Technical Memorandum

RE: Expert review “Consent Application Number RM26.297 – long-term discharge from QLDC WWTP”

Queenstown Lakes District Council (QLDC) is applying for resource consents to authorise the disposal of treated wastewater from the Shotover Wastewater Treatment Plant (WWTP) to the Kawarau River for a period of 35-years; consistent with Enforcement Order (EO) ENV-2025-CHC-001. These consents will enable the eventual transition of the Shotover WWTP disposal infrastructure from the consented, but failed, DAD disposal system and the short-term Kimiākau/Shotover River emergency discharge, to a permanent, fit-for-purpose discharge. The activities for which consent is sought are:

Figure 1: *Proposed pipeline and outfall location for the discharge of treated effluent.*

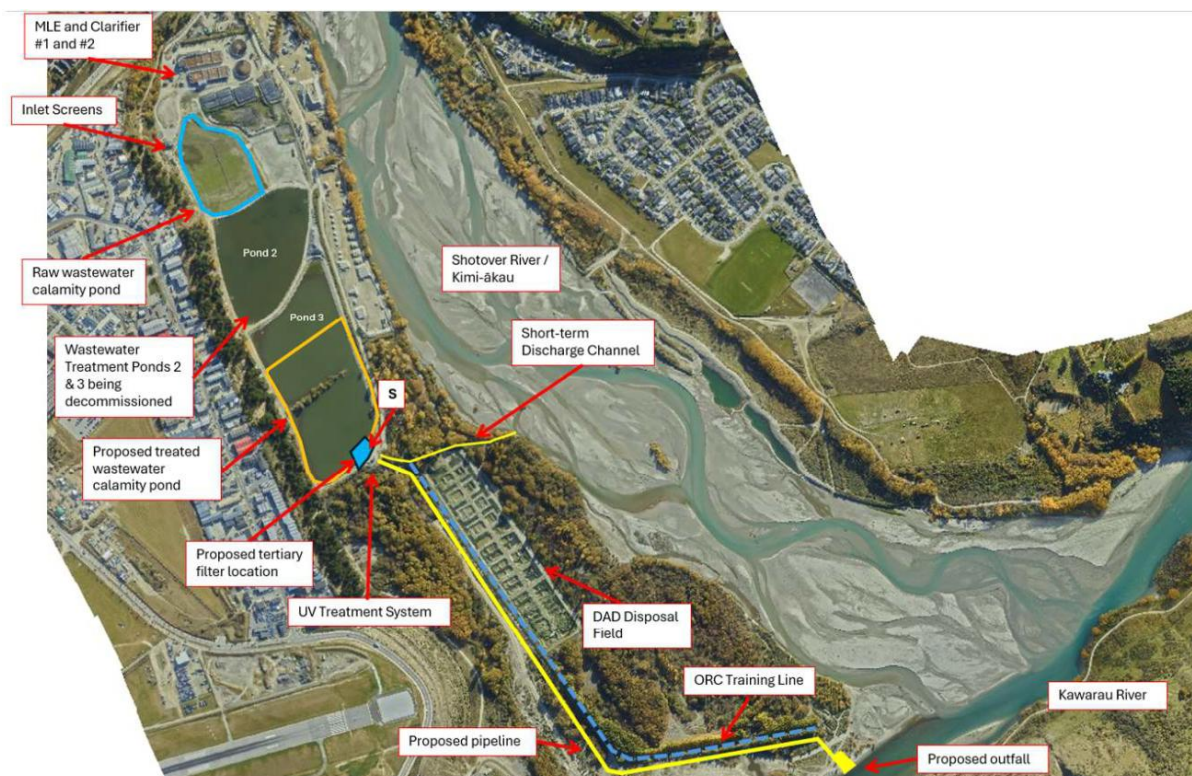
Preliminary details have been provided only for the rock outfall option at this stage, with the Applicant deciding on their preferred option as the consenting process continues (**Figure 1**).

Outfall location

No discussion is provided to justify the location of the proposed outfall, which is immediately adjacent to the upstream edge of the Shotover River/Kimiākau Delta and the downstream end of the ORC Training Line. As discussed later, a rock discharge structure will act as a groyne, with the greatest potential for erosion effects immediately downstream i.e., on the Shotover River/Kimiākau Delta and potentially on the end of the Training Line. The location proposed currently is also on land managed by the Department of Conservation. This could be problematic.

Since no justification is provided for the location proposed currently for the outfall, it is unclear why the outfall could not be a simple extension of the straight pipeline (**Figure 2**).

Figure 2: Proposed pipeline and outfall (solid red line) and a possible shorter alternative (dotted red line).

Such an option would appear to have several advantages, including:

- A shorter length;
- Avoiding two relatively sharp bends in the existing pipeline;
- Remains largely within land owned by QLDC;
- Likely a more stable location with respect to fluvial processes; and
- No change to the assimilative capacity of the Kawarau River at the point of discharge.
